City of El Paso – City Plan Commission Staff Report

Case No: SUSU15-00072 Copia Pond
Application Type: Resubdivision Combination
CPC Hearing Date: December 3, 2015

ATTACHMENT 3

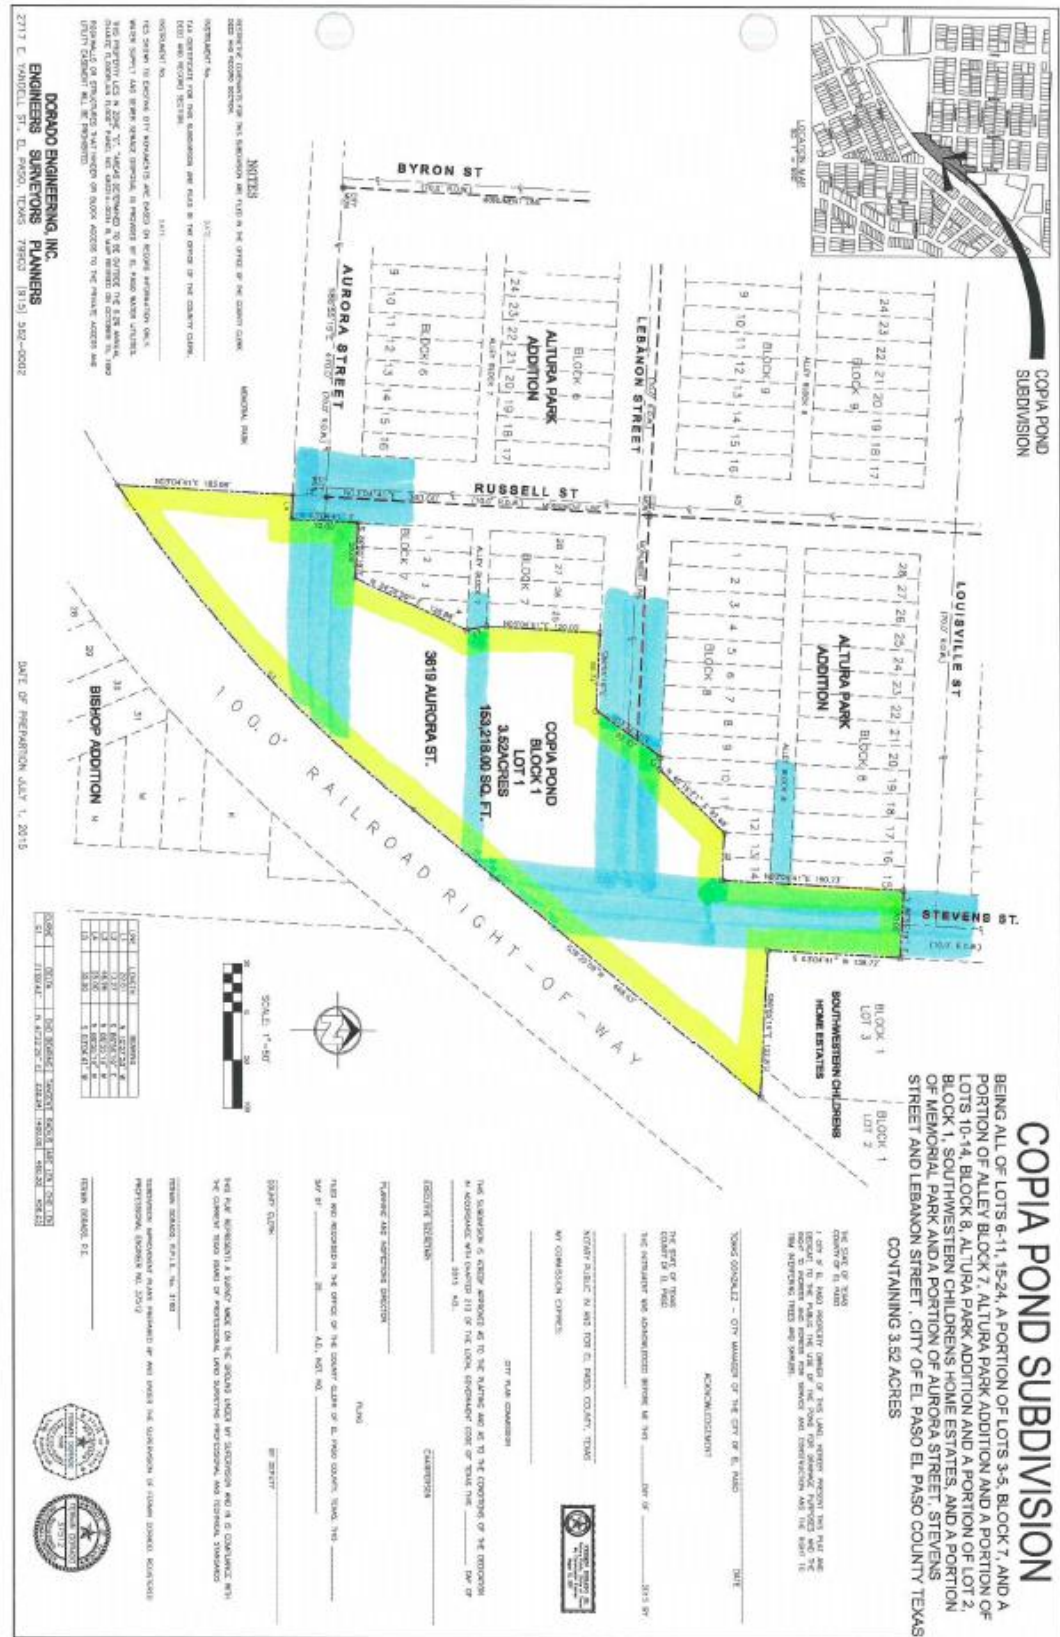
5. Applicant must comply with Section 19.15.160.D.6 which states that alley cannot dead-end.
6. ROW to be vacated by the replat should be shown on the final plat with a note stating "ROW to be vacated by this replat."

7. Provide reason for replat on the final plat.
8. Remove zoning information from the preliminary plat.

9. Add the Owner, Surveyor and the school district information on the final plat.
10. Illustrate the location of the “private access and utility easement” on both plats.
